TECHNICAL SERVICE BULLETIN

NO.: SU005–96

LAND CRUISER SUSPENSION BUSHING CHANGE

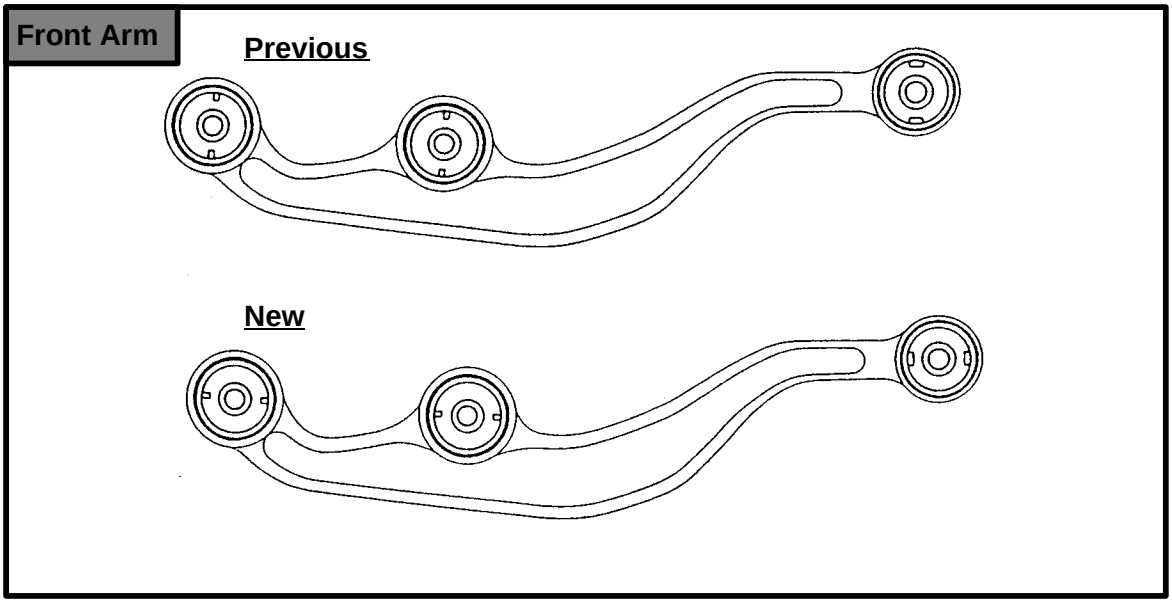
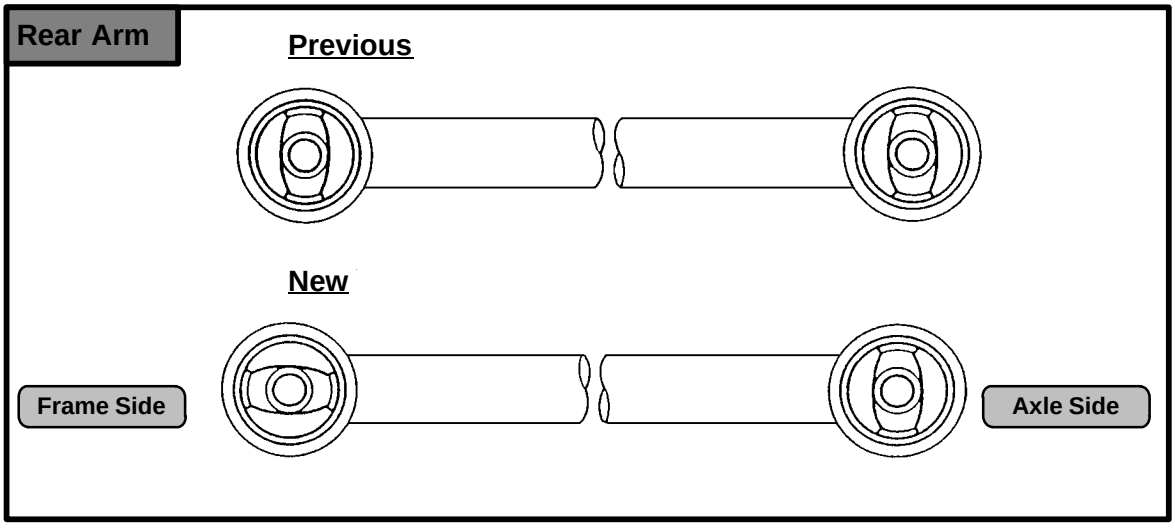
PREVIOUS PART NUMBER	NEW PART NUMBER	PART NAME
48610–60021	48610–60022	Arm Assembly, Leading
48061–60010	Same	Bushing Sub–Assy, Lower Arm
48702–60050	Same	Bushing Sub–Assy, Control Arm
48720–60011	48720–60012	Arm Assembly, Lower Control
48702–60040	Same	Bushing Assembly, Lower Control Arm

NOTE: The new parts should be replaced as left and right sets on previous vehicles. When replacing arm assemblies make sure the bushing orientation is the same on each side of the vehicle.

LEADING ARM BUSHING REPLACEMENT:

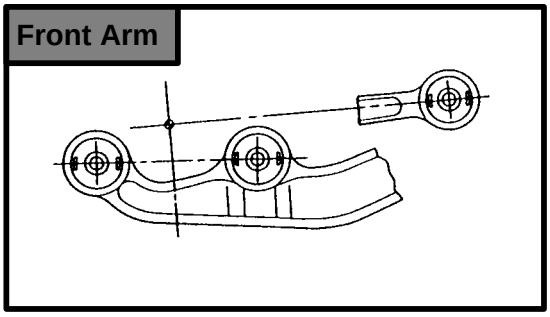
Using suitable adapters and a press replace the bushings in the leading arm.

CAUTION: Note orientation of replacement bushings
